**PLANNED UNIT DEVELOPMENT  
& SUBDIVISION STAFF REPORT****Date: July 5, 2012****DEVELOPMENT NAME** Dawson Estates Subdivision, Re-subdivision of Lot 1**SUBDIVISION NAME** Dawson Estates Subdivision, Re-subdivision of Lot 1**LOCATION** North terminus of Dawson Drive**CITY COUNCIL  
DISTRICT** District 4**AREA OF PROPERTY** 1 Lot / 0.4 ± acres**CONTEMPLATED USE** Planned Unit Development Approval to allow reduced front yard setbacks, and Subdivision approval to create 1 lot.**TIME SCHEDULE  
FOR DEVELOPMENT** Not provided.**ENGINEERING****COMMENTS** 1. On the plat, show the location (if any) of wetlands or state that there are no wetlands present if applicable. 2. Provide all other information required for a Final Plat review.**TRAFFIC ENGINEERING****COMMENTS** Driveway number, size, location, and design to be approved by Traffic Engineering and conform to AASHTO standards.**URBAN FORESTRY****COMMENTS** Property to be developed in compliance with state and local laws that pertain to tree preservation and protection on both city and private properties (State Act 61-929 and City Code Chapters 57 and 64).**FIRE DEPARTMENT****COMMENTS** All projects within the City of Mobile Fire Jurisd

# SITE PLAN

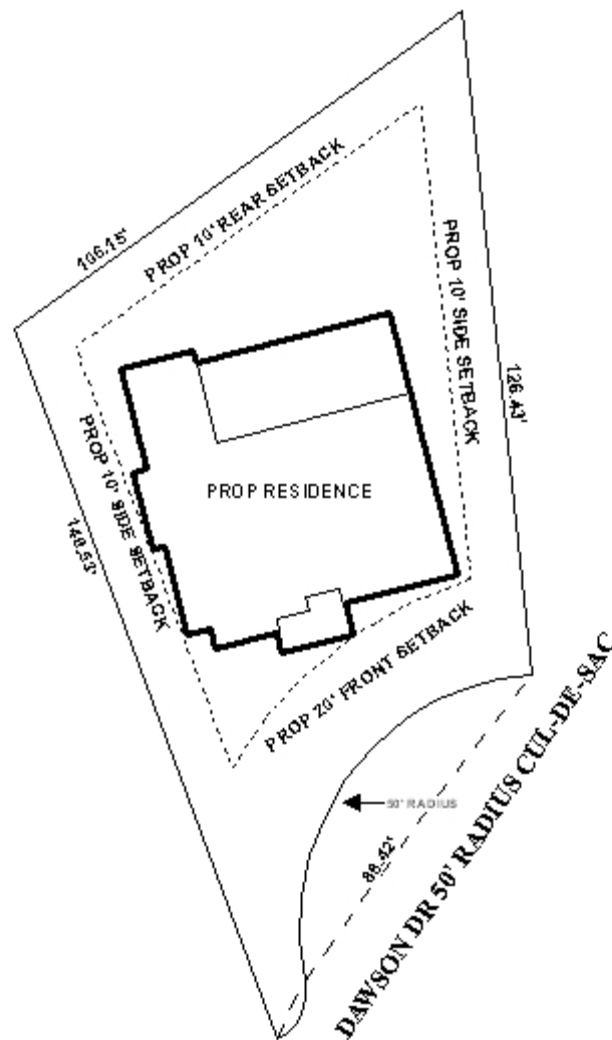
The site plan does not indicate any driveway or parking area. The Zoning Ordinance requires that at least two parking spaces be provided for a single-family residence, and that they not be located within the required front setback. The site plan should be revised to depict a driveway

and parking area. It should be noted that since the site has limited frontage on a cul-de-sac, it should be limited to one curb-cut, with the size, design and location to be approved by Traffic Engineering and conform to AASHTO standards.

The site plan also does not depict any equipment associated with air conditioning units. Typically the condensers are located outside, and in floodzones, the equipment must be elevated. The site plan should be revised to depict any exterior HVAC equipment, generators, etc., that might be prone to location in required setbacks: any ancillary equipment greater than 3-feet in height cannot be located within a required front, side or rear yard setback.

If the front setback is reduced to 20-feet, as requested, a corresponding increase in the rear yard setback might be appropriate. The site plan submitted depicts side and rear yard setbacks of 10 feet. The applicant may wish to provide a 15-foot rear yard setback in order to discourage any construction near the water.

- 1) Revision of the site plan to depict and label a front setback of 20 feet, side yard setbacks of 10 feet each, a rear yard setback of 15 feet, and a maximum site coverage of 29%;

- 4) Revision of the site plan to depict parking for two vehicles outside of the front setback area, as well as any driveway (noting that the lot is limited to one curb-cut);

- 5) Revision of the site plan to depict any HVAC, generators or similar items that will be placed on site, to ensure that they meet all required setbacks;
